# Noyac Bay

Suite 307  
ORIGINAL LAYOUT  
INVENTORY SUITE  
NEW

**\* SUITE 307 \* (INVENTORY SUITE)**

**SUITES 307 - NOYAC BAY (inventory suite)**

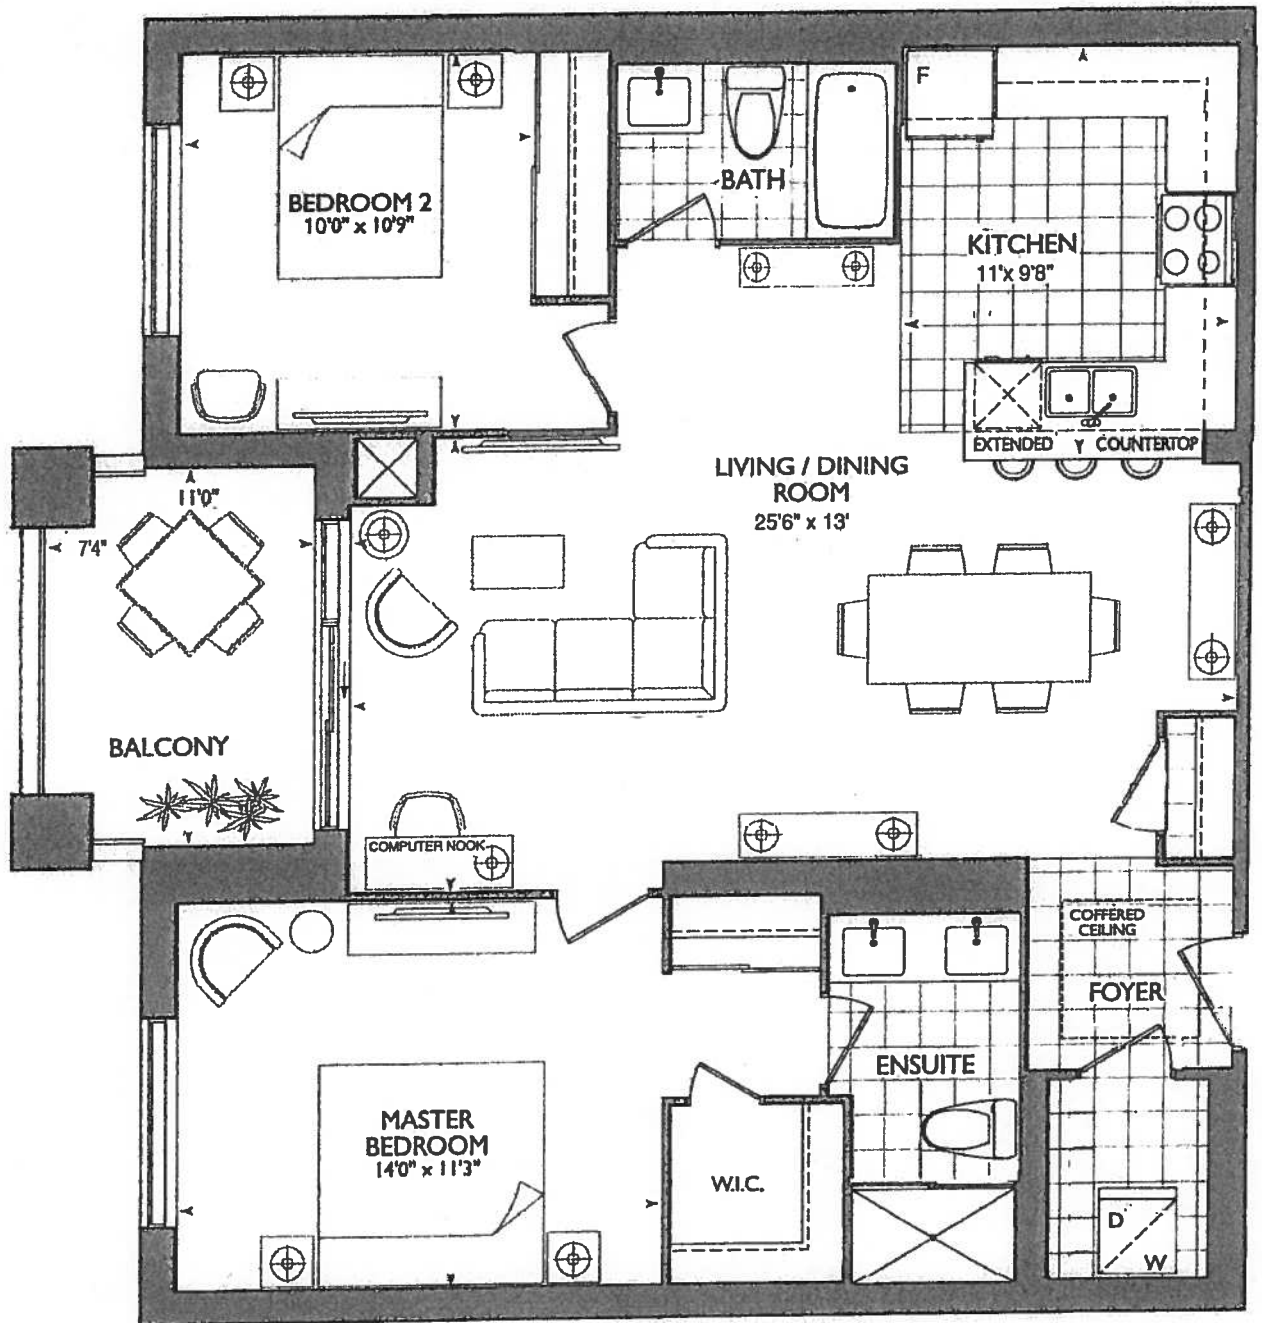
NEW PLAN

- REMOVED DEN
- REVISED KITCHEN

\*REVISED LAUNDRY DOOR SWING &  
ENSUITE WALL AS PER THIS BROCHURE

• DPT - UPG #1 - Kitchen  
LAYOUT #1  
1ST UPGRADE APPLIANCE  
PKG.

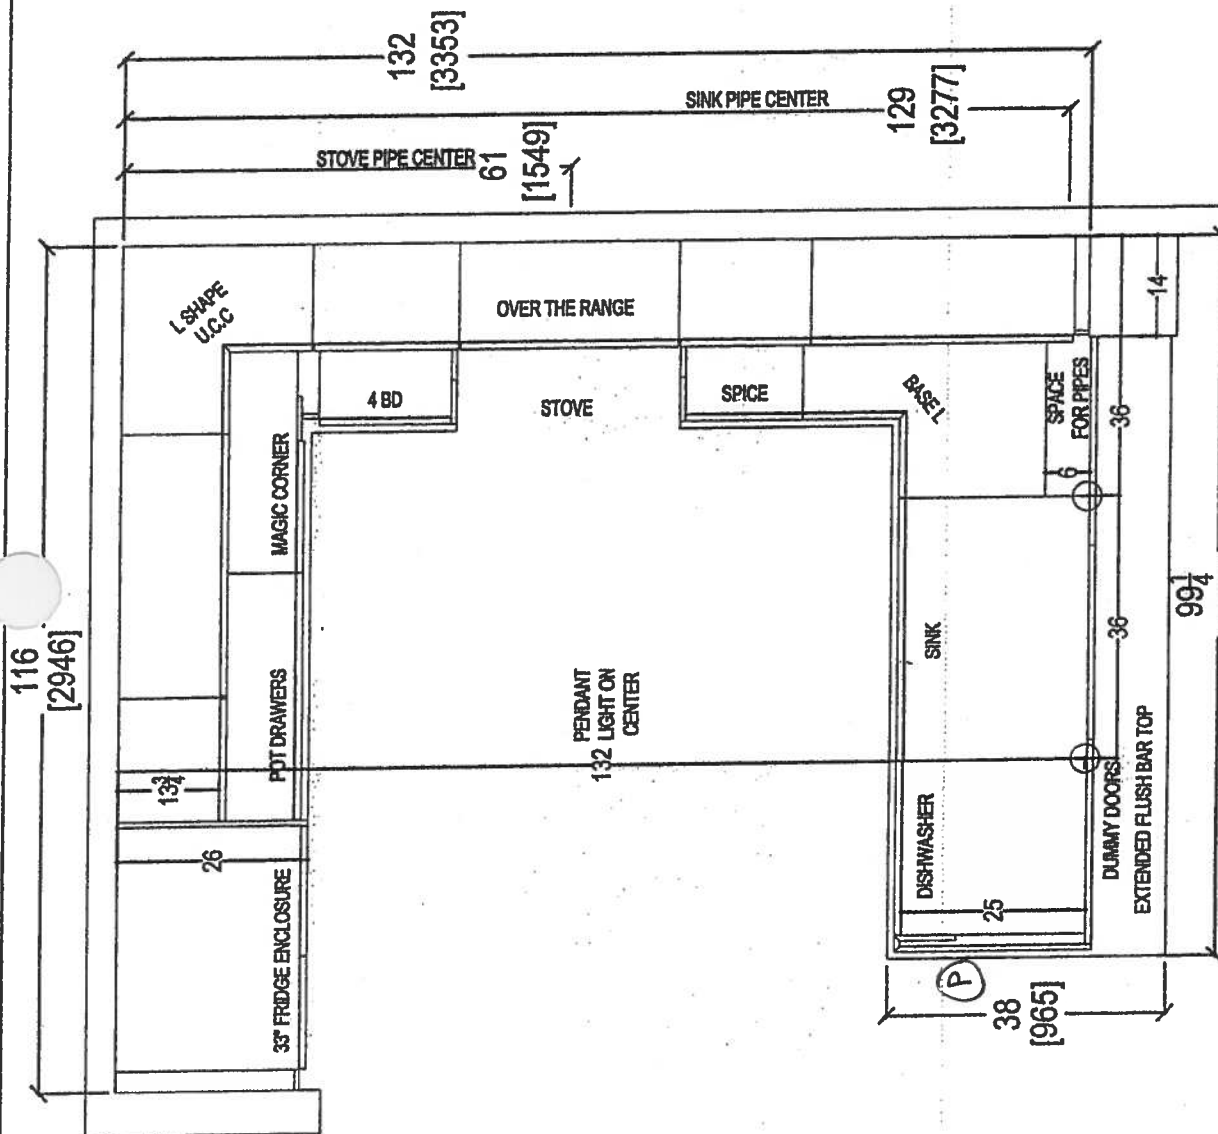
- $\textcircled{P}$  = PLUG PENINSULA
- $(x2)$  = CAPPED PENDANT LIGHTS OVER PENINSULA
- $(x7)$  = PUCK LIGHTS
